June 4, 2019

**RE: Reinitiation of Consultation on Long Term Operations of the State Water Project and Central Valley Project**

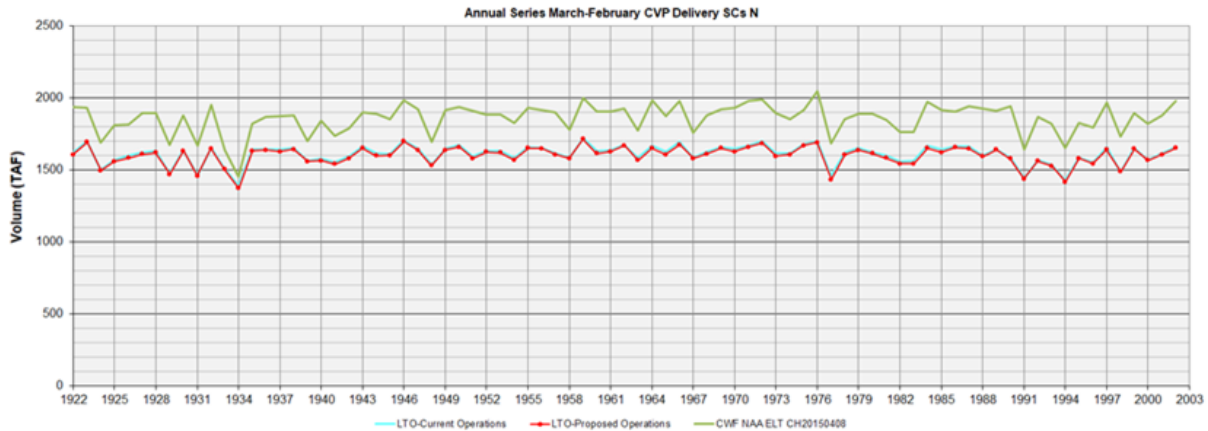
Unlike prior consultations and environmental reviews, this biological assessment only models the effects of recent historic levels of water diversions by Sacramento River Settlement Contractors instead of full contract amounts. The modeling assumptions in the BA explicitly states that the CalSim modeling only analyzes historic diversions by the Sacramento River Settlement Contractors, not the full contract amounts. *Id.*, Appendix D at 46 (“Land-use based, full buildout of contract amounts, except for Settlement Contractors represented with historical diversions.”); *id.* at 47.<sup>5</sup>

CalSim results from the BA also demonstrate that the Bureau of Reclamation changed the assumptions regarding the amount of water diversions by Sacramento River Settlement Contractors in both the Continued Operations Scenario and the Proposed Project. In recent previous ESA consultations and NEPA analyses the Bureau of Reclamation analyzed the effects of full contract amounts by the Sacramento River Settlement Contractors, including the California WaterFix biological opinions, California WaterFix Final EIS/EIR, and the 2015 Final EIS on Long Term Operations of the CVP and SWP. In contrast, here the Bureau of Reclamation has significantly reduced water diversions by Sacramento River Settlement Contractors in the model, limiting those diversions to historic levels rather than full contract

amounts. Staff from the U.S. Fish and Wildlife Service confirmed that the CalSim model results show a significant reduction in water diversions by Sacramento River Settlement Contractors as compared to the California WaterFix modeling, providing the graphic below, and that this was a result of changes in the assumptions. See Email from Derek Hilts to Doug Obegi dated March 28, 2019.

The Sacramento River Settlement Contractors have never diverted their full contract amounts, and in most years total diversions are only 75% or less of full contract amounts. As a result, this change in modeling assumption significantly altered the modeling results, including causing a significant increase in carryover storage in Shasta Reservoir as compared to those earlier modelling efforts.
